City of Brisbane
Open Space Plan

Figure 4
Brisbane Acres
**Butterfly Habitat/
Ridgelines**

17.12.040.L - Ridgeline: Can we get a more detailed description of "Figure 4 of the Open Space Plan." My concern is that the Plan is not a regulatory document and the Plan itself might change in the future. My preference would be to include a Ridgeline map to be adopted with the ordinance so it would remain in place regardless of what happens to the Plan. It would also be easier to identify in the future, without the need to find a separate document and then determine whether we are looking at the correct "Figure 4."

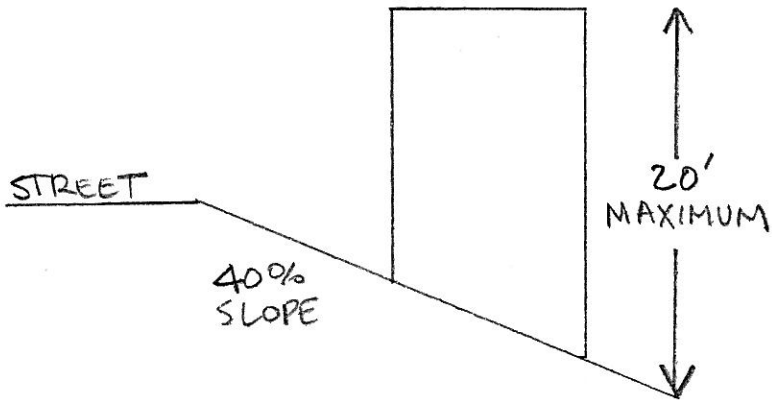
Thanks for copying me in this discussion. I think the incorporation of Figure 4 of the Open Space Plan would significantly clarify the definition of "ridgeline" and make it much easier for all parties to understand what constitutes a "ridgeline" within Brisbane. Certainly it would have made all of our discussions much more straightforward.

I am not opposed to incorporating something by reference but my problem was that I did not think the Open Space Plan should necessarily be that document. I would argue that the Zoning Map is adopted by ordinance and is a regulatory document, whereas the Open Space Plan is not. My preference would be to treat the map the same as we handle signs and include it as part of the ordinance - or, it could be separately adopted, maybe as a separate section of the ordinance, and then have that document incorporated by reference.

L. Ridgeline. Structures shall be located below ridgelines in a manner that will preserve public views of the San Bruno Mountain State and County Park. *Development on any site through which a ridgeline runs as identified in Figure 4 of the Open Space Plan shall be subject to design permit approval.*

What's the best way to deal with the ridgeline map? It doesn't sound like you want to incorporate it by reference, as BMC Section 17.04.020.A does with the Zoning Map. Should we set it up like the figures at the end of the Sign Ordinances (Figures 17.36.020A-1, A-2 & B) and insert it directly into the ordinance, with "Figure 17.12.030" at the top?

L. **Ridgeline. Structures shall be located below ridgelines in a manner that will preserve public views of the San Bruno Mountain State and County Park. Development on any site through which a ridgeline runs as identified in Figure 17.12.030 Figure 4 of the Open Space Plan shall be subject to design permit approval.**
